# Service Bulletin

Category U	Applicable Model/s 1988-'90 626/MX-6 w/ A/C	Subject REFRIGERANT LEAK FROM INLET/OUTLET PIPE OF RECEIVER/DRIER TANK	Bulletin No. 008/90 Issued 12/19/90 Revised
---------------	---	--	---

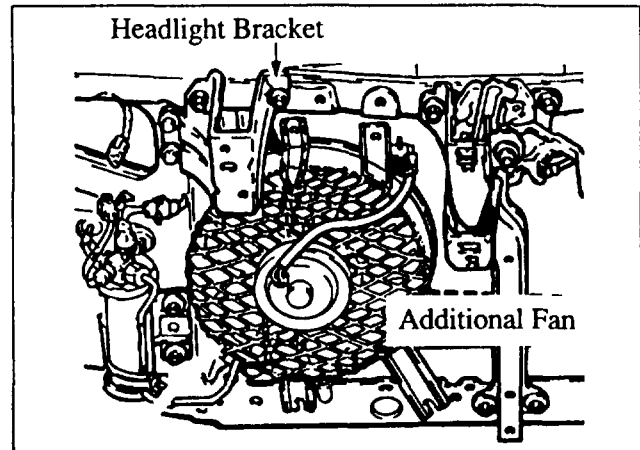
It has been found that the inlet or outlet pipe of the receiver/drier tank may develop a pinhole at the area shown below where the pipes are held by small steel clips. This may result in a refrigerant leak.

Galvanic corrosion occurs between the aluminum pipe and the steel clip. This condition is more likely to develop in geographic areas that use large amounts of salt on the roads and highways.

- If a refrigerant leak is suspected, inspect the pipes of the receiver/drier tank.
- The inlet/outlet pipes are available as a service part. Refer to the parts information in this bulletin.
- In order to prevent galvanic corrosion from recurrence, place vinyl tape (insulator tape) between the steel clip and the aluminum pipe.

### NOTE:

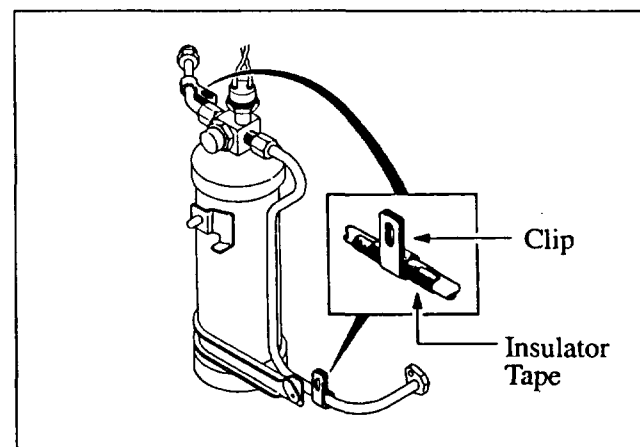
3. Remove the receiver/drier tank and replace the necessary pipe.

When replacing the pipes, place the vinyl tape (insulator tape) between the steel clip and the aluminum pipe in order to prevent galvanic corrosion from recurrence.
